# EXECUTIVE SUMMARY

This addendum is intended to summarize changes to the LTCP that have occurred as a result of negotiations with US and Ohio EPA since the submittal of the original plan. As part of these negotiations, both the scope of the LTCP and facilities at the WWTP have been discussed. This addendum is intended to document those changes to the plan that have occurred as a result of the negotiation process.

### ES.11.1. Revised LTCP Projects and Beneficial Impacts (Update to Section ES.5 and ES.6)

Figure ES.6: Recommended Plan for CSO Control (Revised Figure ES.5)

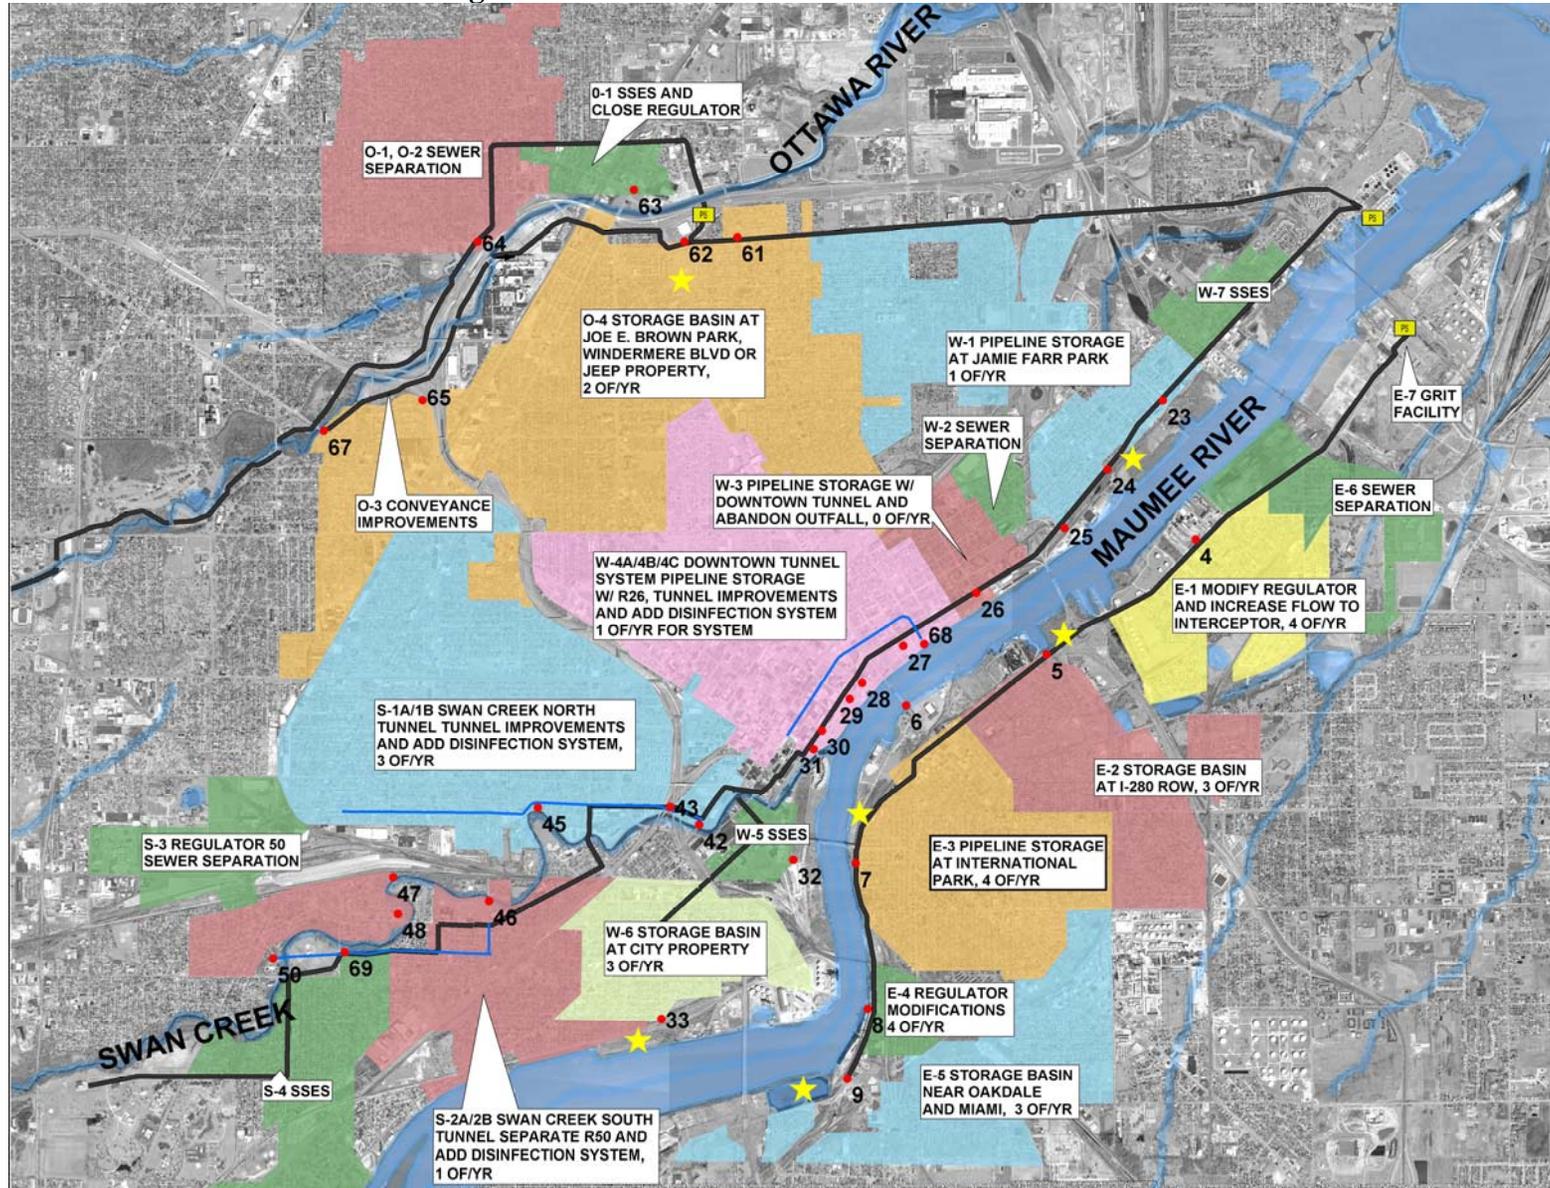
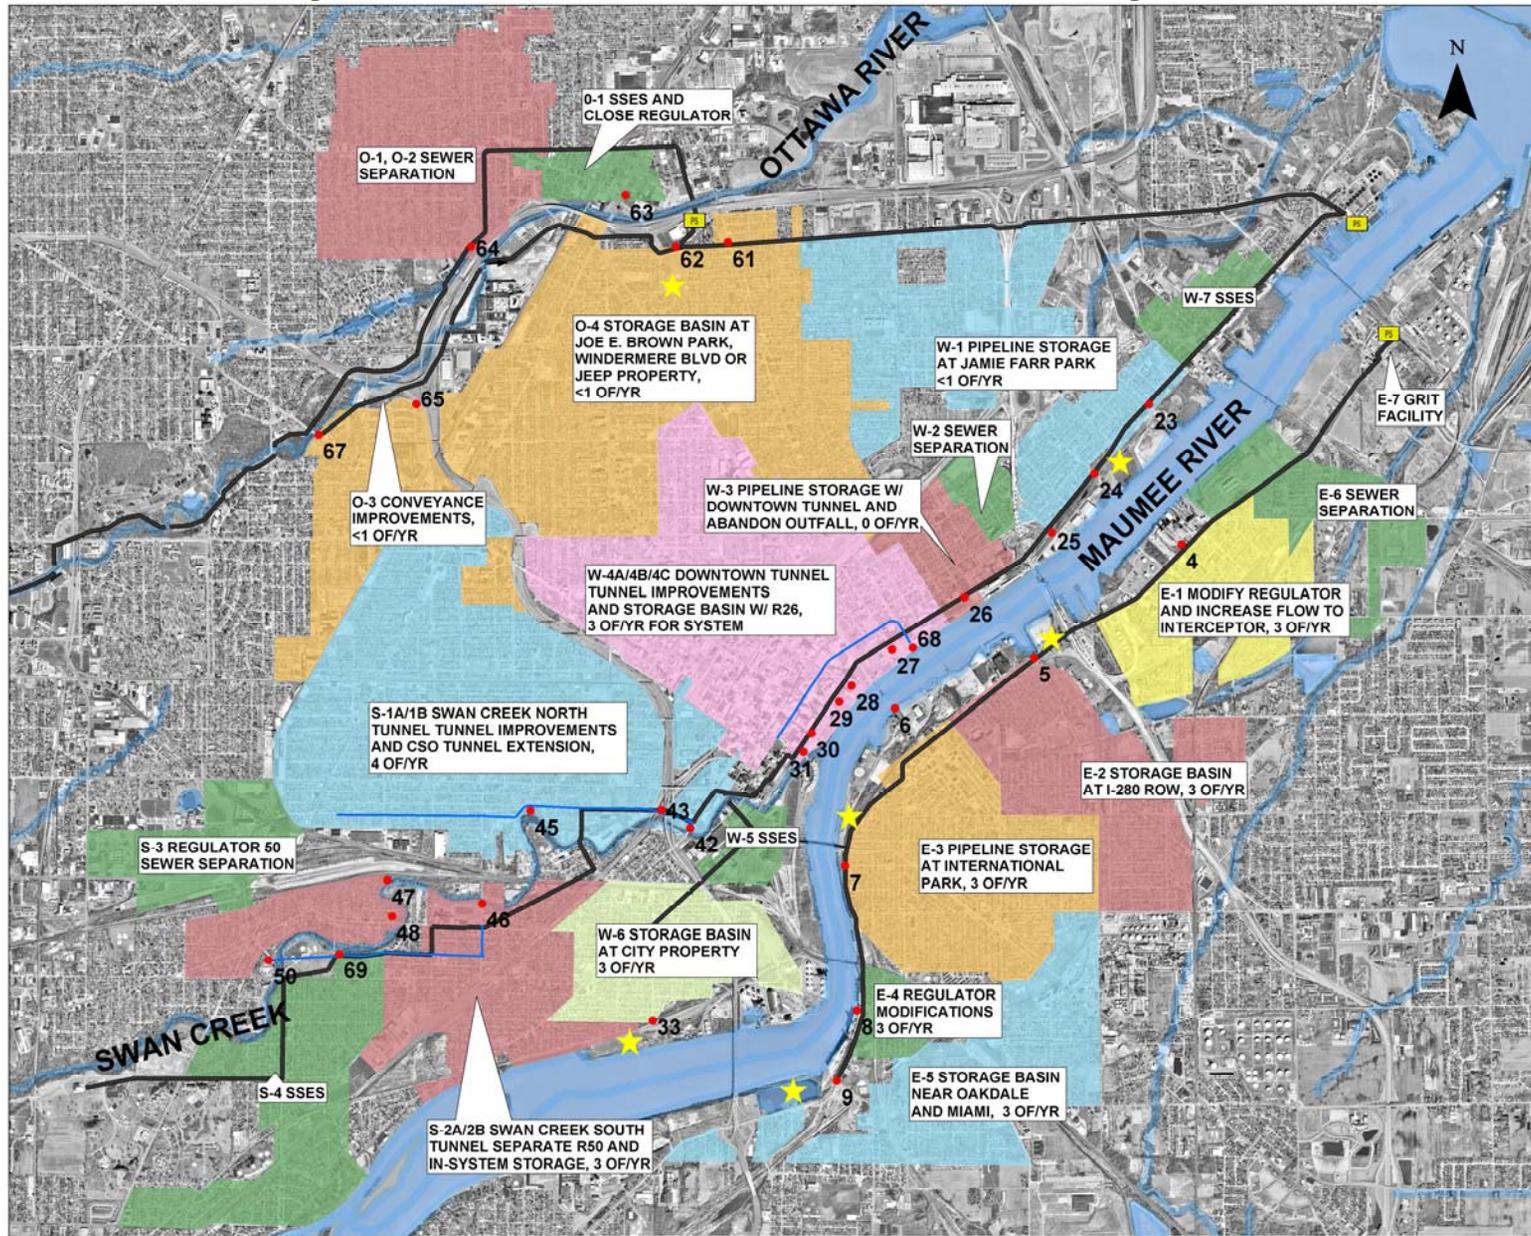
The revised plan reflects an additional commitment by the City of approximately \$60 million toward CSO control, and it emphasizes solutions with highly predictable outcomes (storage, separation, source control) rather than solutions that rely on treatment technology that may be difficult to accomplish reliably. The 2009 LTCP includes a revised approach to evaluate the effectiveness of CSO control projects. Details of the post-construction evaluation process are presented in Section 15.6.1.

The revised LTCP projects are described in this section. Additional detail is provided in the Addendum to Chapter 13. Table ES.25 provides a summary of revised LTCP projects and costs. Figure ES.6 provides a schematic of the revised Recommended Plan.
